Re: Application for Renewal of License
Control No. 137481
Request for additional information

Items 1 through 6 are provided in response to your request for additional information regarding Application for Renewal of License, Control No. 137481.

Radiological Characterization of Building 747
South Charleston Technology Park, WV
Union Carbide Corporation, A Subsidiary of The Dow Chemical Company

Figure 1

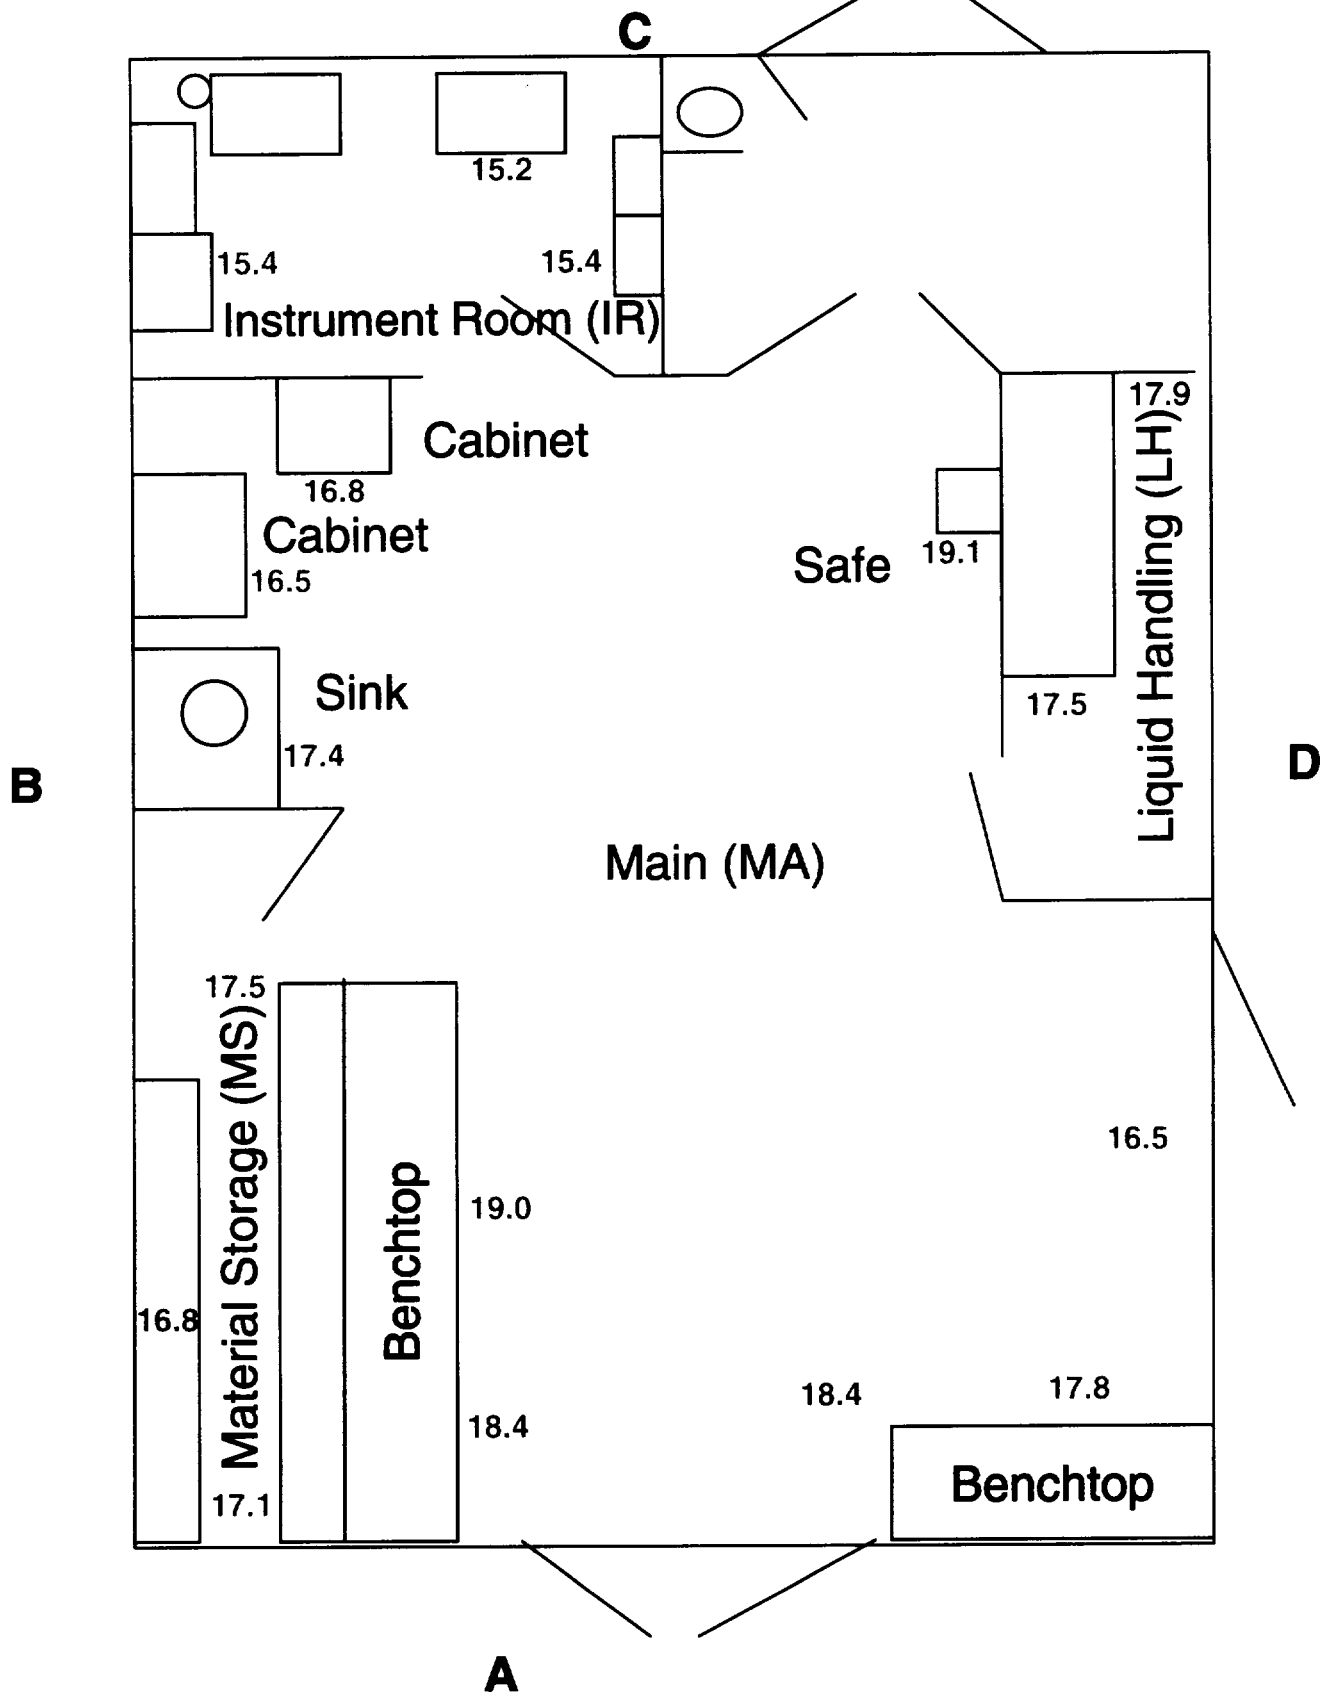
3. The Hewlett-Packard Electron Capture Detector is generally licensed.
The 3M Static Meter Model #703 is generally licensed.
4. The units of measure have been correct on Figure 1 and Attachment 1 (enclosed).
5. We wish to remove the Institute Plant from our license. We have never used radioactive material in that facility.
6. The enclosed Radiological Characterization of Building 747 addresses the use of Building 747 and explains the wipe analysis with instrument efficiency.
